LS430

OUTLINE OF NEW FEATURES

The following changes are made for the previous LS430.

7. Drive Shaft

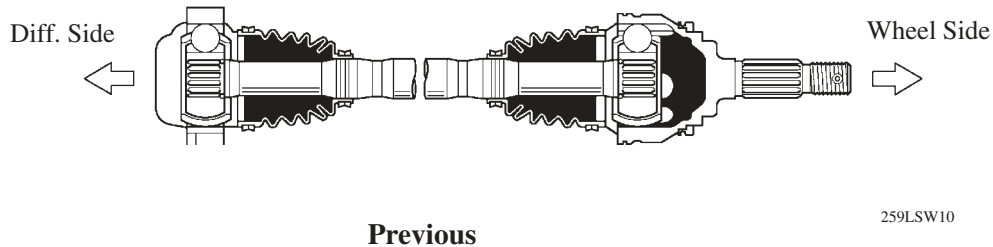
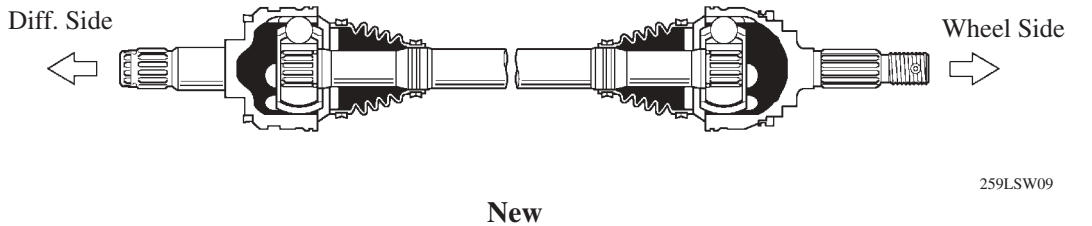
The drive shaft and the differential side gear, which were previously joined with bolts, have been changed to an integrated construction of the differential side gear shaft.

15. Combination Meter

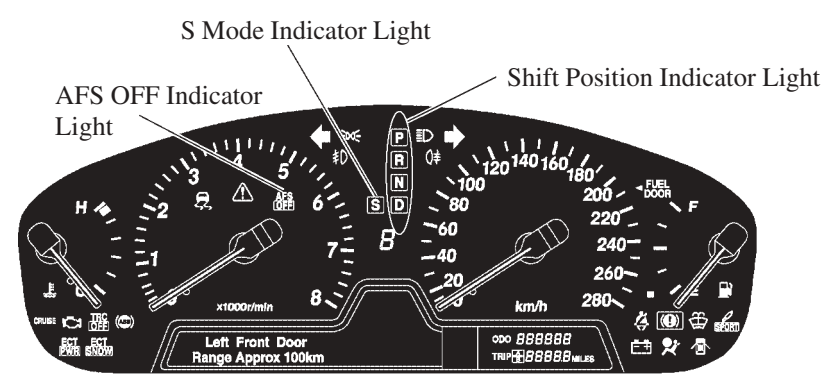
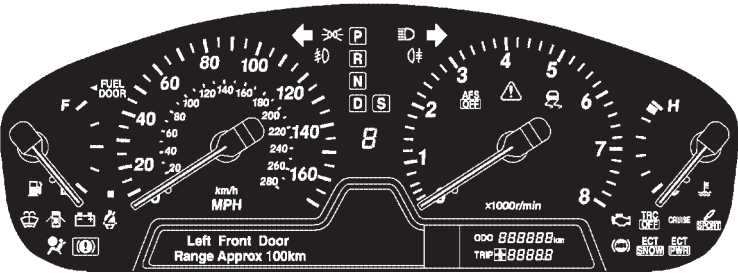
Item	Outline
Indicator Light	Along with the installation of the A761E automatic transmission, the shift position indicator light has been changed. Also, to support the multi-mode automatic transmission, shift range and S mode indicator lights have been added.
Multi-information Display	Warning messages for the dynamic laser cruise control system have been added only for Australia model.

21. Key Reminder

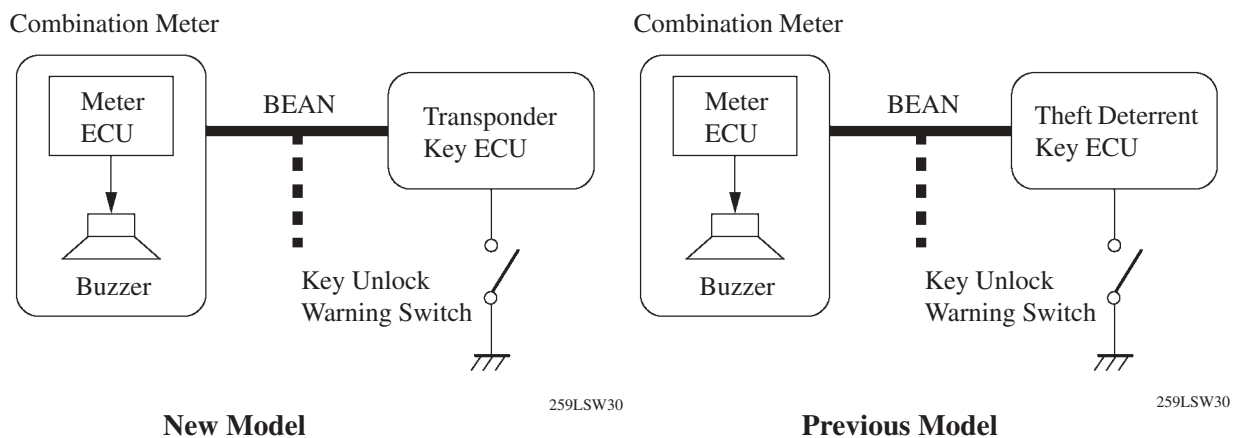
Master ECU has been changed from the theft deterrent ECU to the transponder key ECU.
